Penrith Local Planning Panel

Determination and Statement of Reasons

Development Application DA17/0386 at Lot 32 DP 1283 & SP 79056, 15 – 17 Dent Street, Jamisontown – Demolition of Existing Structures & Construction of Five (5) Storey Residential Flat Building containing 19 Apartments & Two (2) Levels of Basement Car Parking.

Subject: **Proposed Residential Apartment Development at 15-17 Dent Street, Jamisontown**

DRAWING TITLE
**SHADOWS FROM NEIGHBOUR -
SHEET 1**

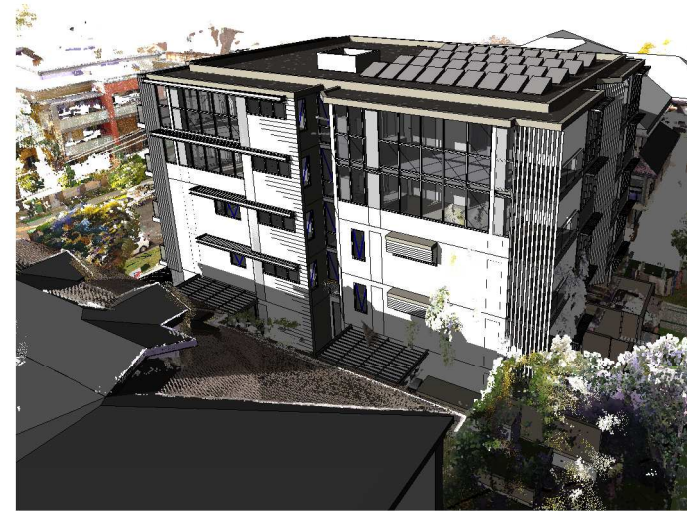
- Provision of further information (including solar access diagrams at hourly intervals in mid-winter or lesser period periods as may be required) to demonstrate that the current proposal complies with the Apartment Design Guide requirements concerning solar access to living rooms of proposed units; or
- Submission of amended plans and supporting information that demonstrates compliance with the Apartment Design Guide requirements concerning solar access to living rooms of proposed units which shall not increase amenity impacts to neighbours.

through an Unexpected Finds Protocol. In addition, an environmental management plan can be required as a condition of consent prior to the issue of a Construction Certificate to provide greater detail as to the strategies that will be in place in the event of encountering contaminated groundwater.
<i>Study Rooms</i>	While the study room dimensions of 2m x 3m do not meet the minimum dimensions for bedrooms under the ADG, the stamped approved plans can be amended in red to remove the walls and ensure the study rooms are not enclosed and are part of an open plan living area.
<i>Design Rationale for Building Location</i>	The building is situated to ensure that the units of the proposed development receive adequate sunlight given the overshadowing that is anticipated from the residential flat building directly to the north (9 Dent Street). In addition, the extent of overshadowing from the proposal to the residential flat building to the south (29-31 Preston Street) is not considered to be detrimental to the overall amenity of the neighbouring site and is reasonable in its impact particularly given the high density zoning of the locality. Overall the building siting is a consequence of the lesser side setback provided by the existing building to the north, the larger side setback provided by the existing building to the south, provision of adequate solar access for the proposed development and minimising overshadowing to the existing units to the south.
